**Item No. 9.1.1**  
**Design Review Committee**  
**February 8, 2018**

**SUBJECT:** **Case 21461: Substantive Site Plan Approval – 1451 & 1435 Hollis Street, Halifax**

Application by WSP Canada Inc. for substantive site plan approval to enable the development of an 8 storey residential building at the southeast corner of Bishop Street and Hollis Street, Halifax.

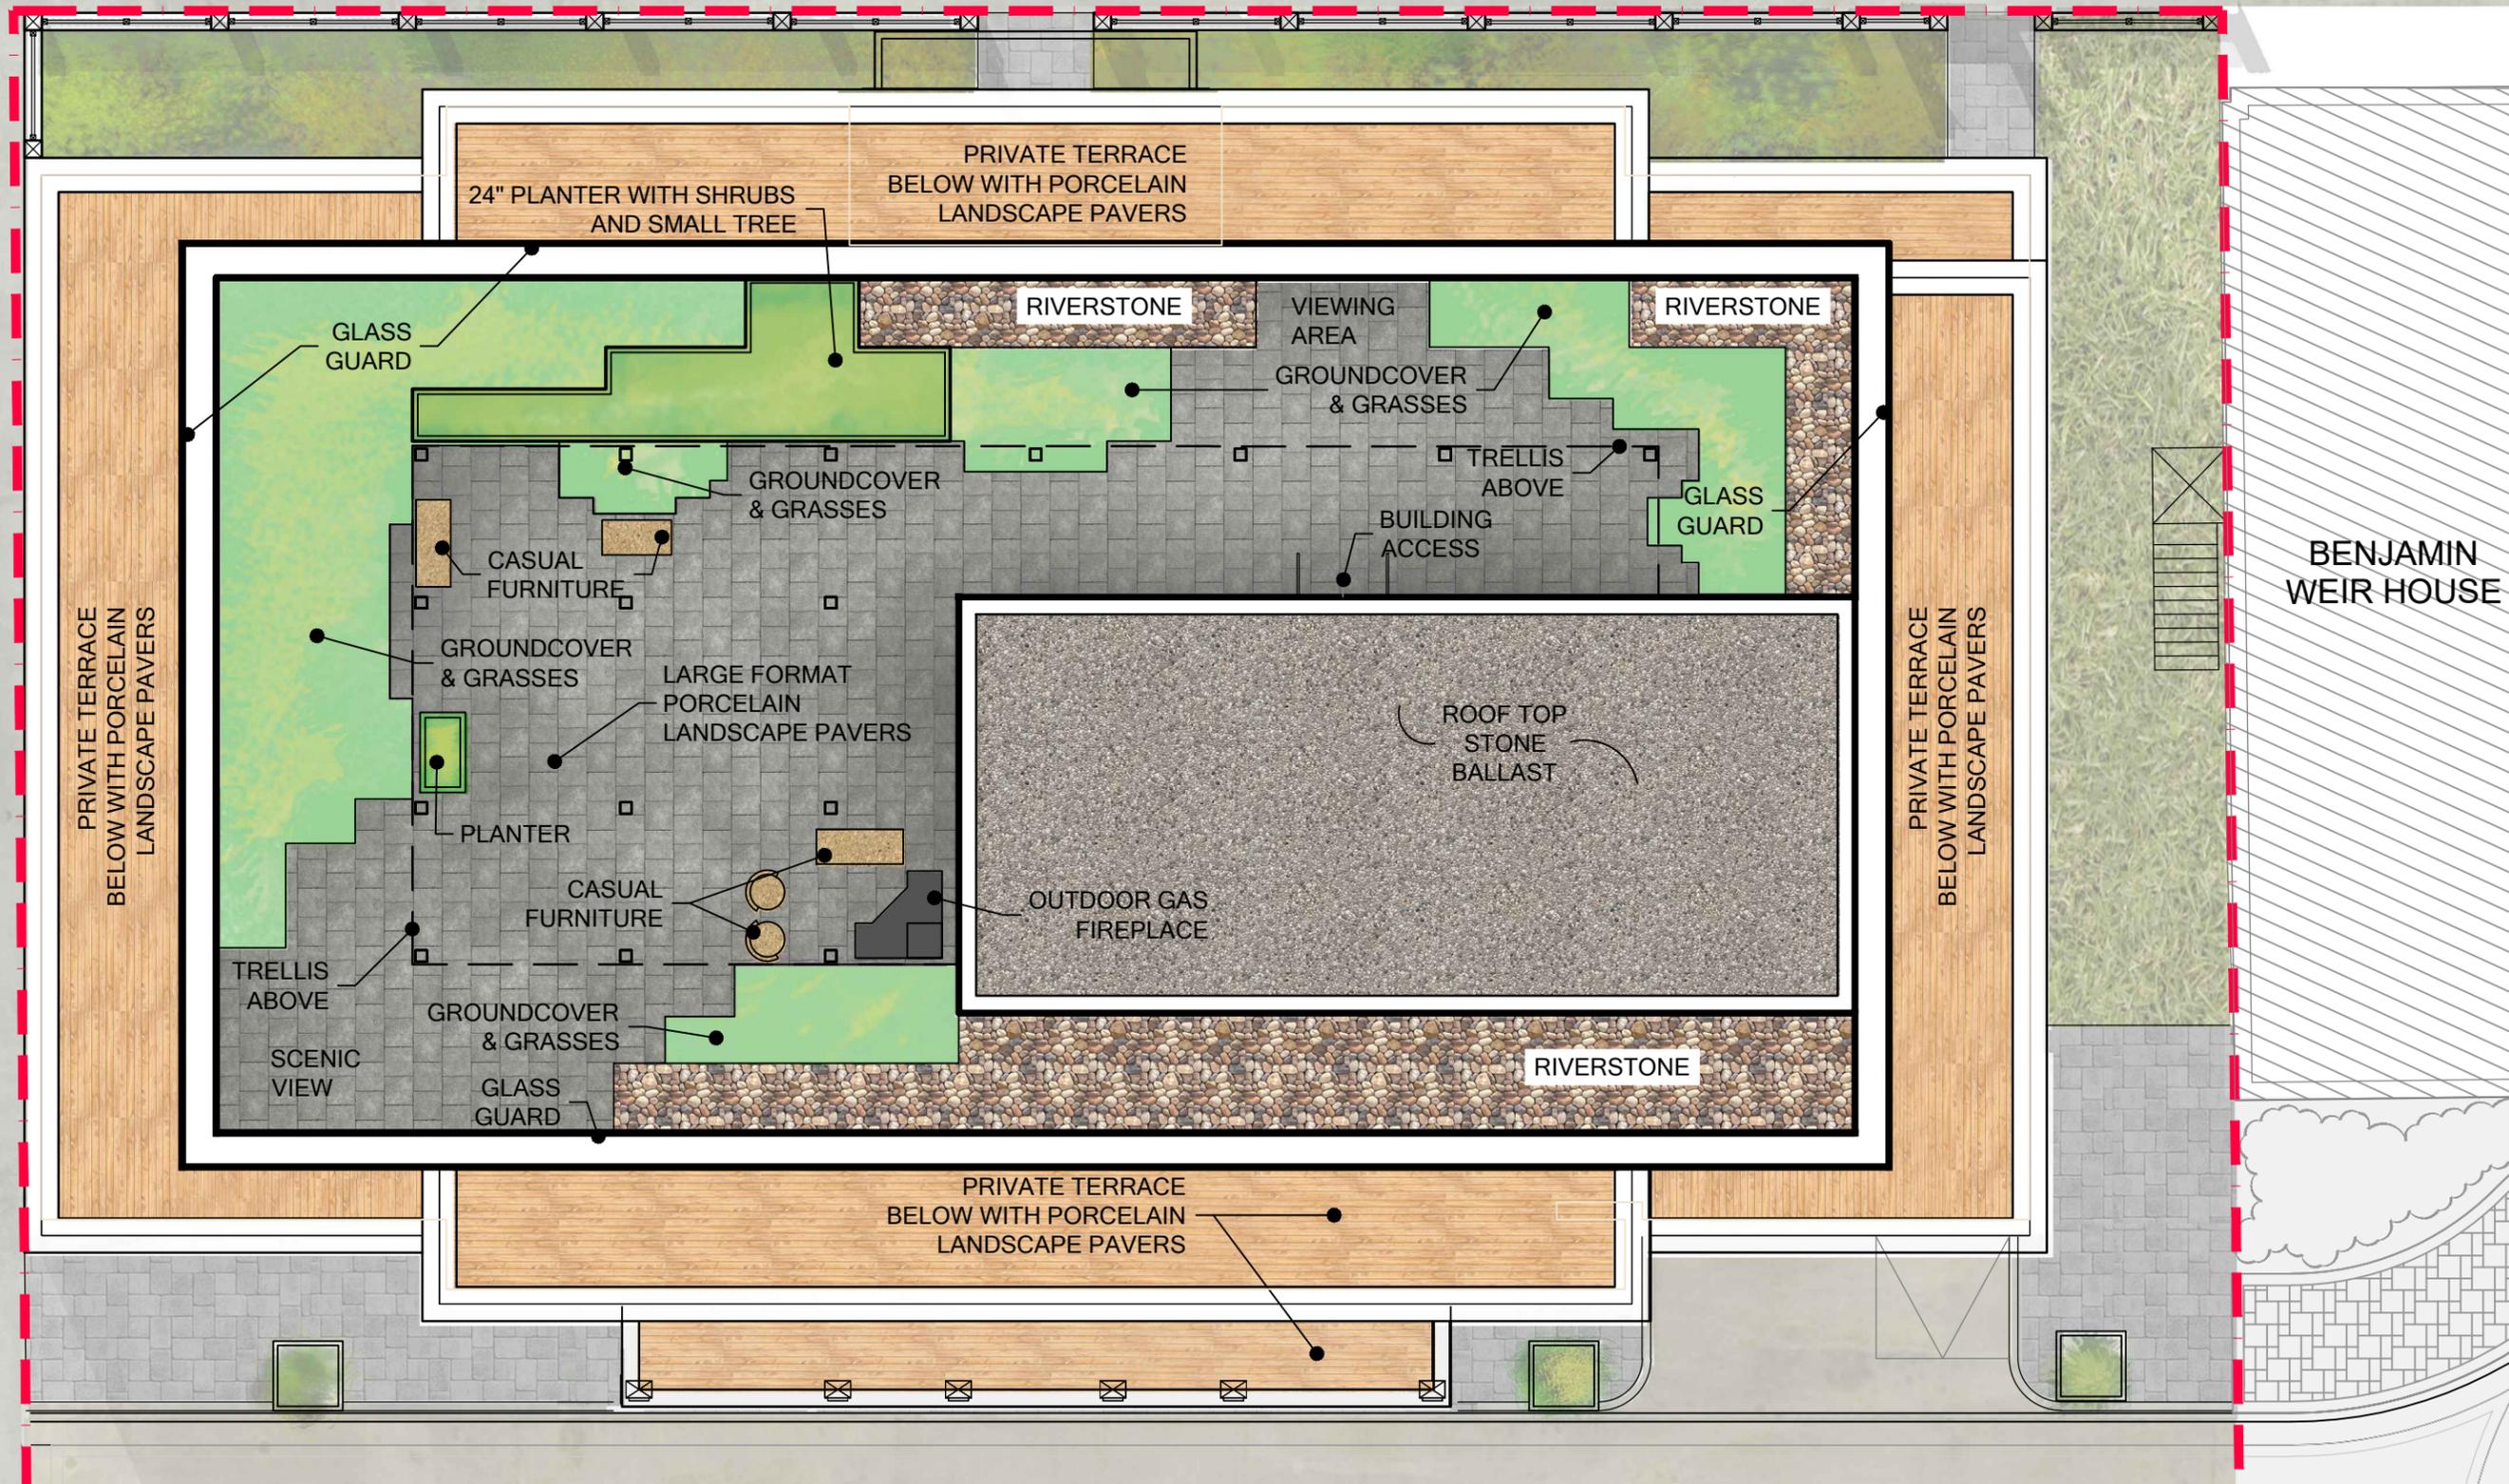
Based on the recommendations from the RWDI Governor's Plaza wind assessment report dated May 26, 2017, Architecture49 believes revising the proposed landscape plan to include planters as shown in the attached sketch will follow the recommendations outlined in page 8 and 9 of the report. These planters will be located to assist in the reduction of wind flow through the seating area and placed in a way to mitigate the wind coming from the predominant wind direction during the summer. The planters will include local plants that provide enough height and coverage to provide adequate protection.
